Notice of Allowability

09/965,524

M. A. Sager

ROWE, RICHARD E.

FIGURE 7

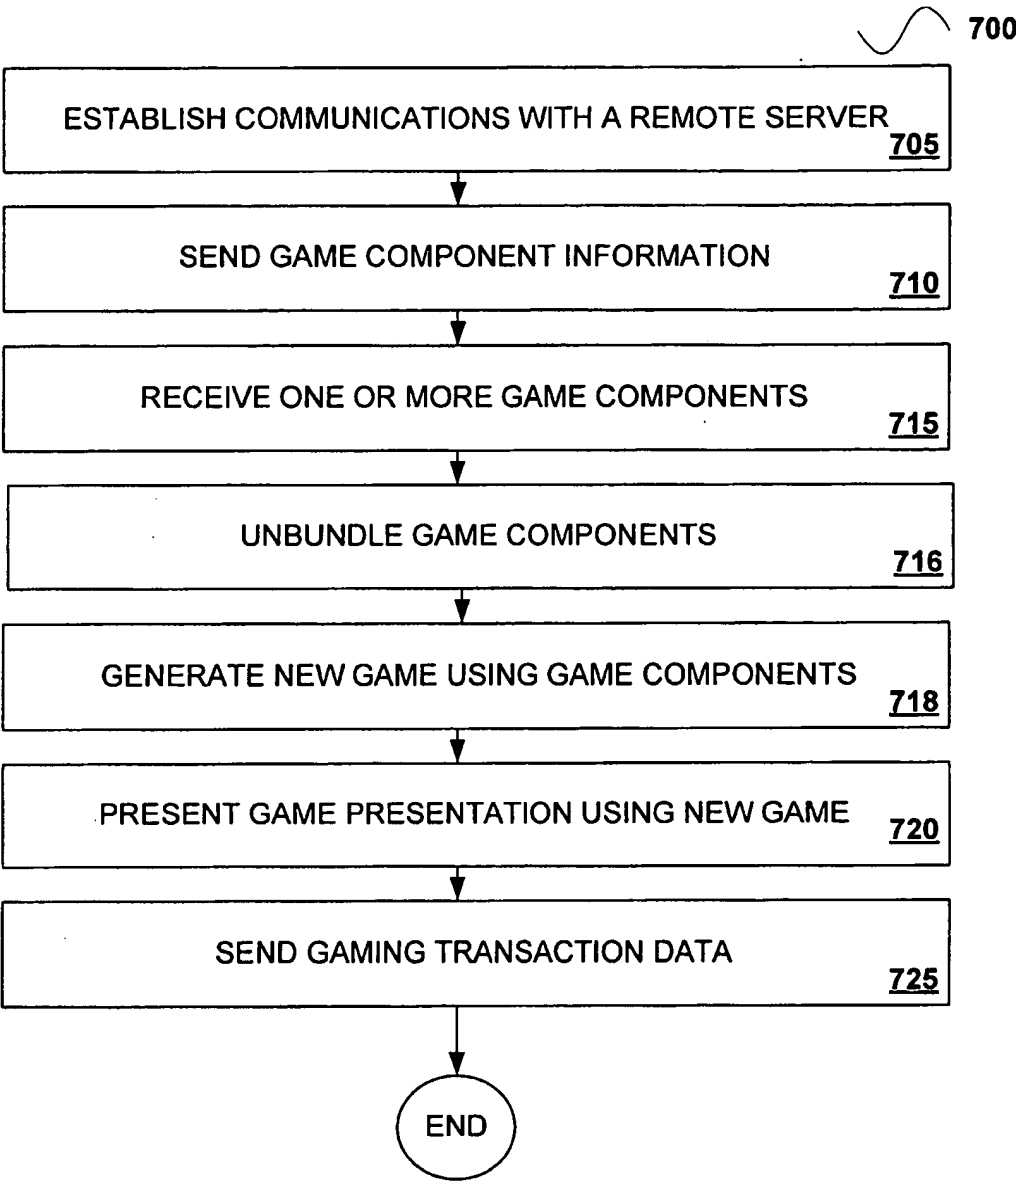
3. The drawings are objected to as failing to comply with 37 CFR 1.84(p)(4) because reference character "710" has been used to designate both step to 'transmit selected items to gaming site' (paragraph 68, fig. 7) and step to 'send game component information' (paragraph 82, fig. 9). Corrected drawing sheets in compliance with 37 CFR 1.121(d) are required in reply to the Office action to avoid abandonment of the application. Any amended replacement drawing sheet should include all of the figures appearing on the immediate prior version of the sheet, even if only one figure is being amended. Each drawing sheet submitted after the filing date of an application must be labeled in the top margin as either "Replacement Sheet" or "New Sheet" pursuant to 37 CFR 1.121(d). If the changes are not accepted by the examiner, the applicant will be notified and informed of any required corrective action in the next Office action. The objection to the drawings will not be held in abeyance.

4. The drawings are objected to under 37 CFR 1.83(a) because they fail to show fig. 9 (it is noted a new figure 7 was provided that may have included a typographical error of '7' for --9-- as described in the specification. Any structural detail that is essential for a proper understanding of the disclosed invention should be shown in the drawing. MPEP § 608.02(d). Corrected drawing sheets in compliance with 37 CFR 1.121(d) are required in reply to the Office action to avoid abandonment of the application. Any amended replacement drawing sheet should include all of the figures appearing on the immediate prior version of the sheet, even if only one figure is being amended. The figure or figure number of an amended drawing should not be labeled as "amended." If a drawing figure is to be canceled, the appropriate figure must be removed from the replacement sheet, and where necessary, the remaining figures must be renumbered and appropriate changes made to the brief description of the several views of the drawings for consistency. Additional replacement sheets may be necessary to show the renumbering of the remaining figures. Each drawing sheet submitted after the filing date of an application must be labeled in the top margin as either "Replacement Sheet" or "New Sheet" pursuant to 37 CFR 1.121(d). If the changes are not accepted by the examiner, the applicant will be notified and informed of any required corrective action in the next Office action. The objection to the drawings will not be held in abeyance.

5. The substitute specification received on 6/12/06 has been accepted; although, step 710 is duplicated in use between figure 7 and 9 as noted above.

Not Accepted/Approved *MLL*
8/30/06
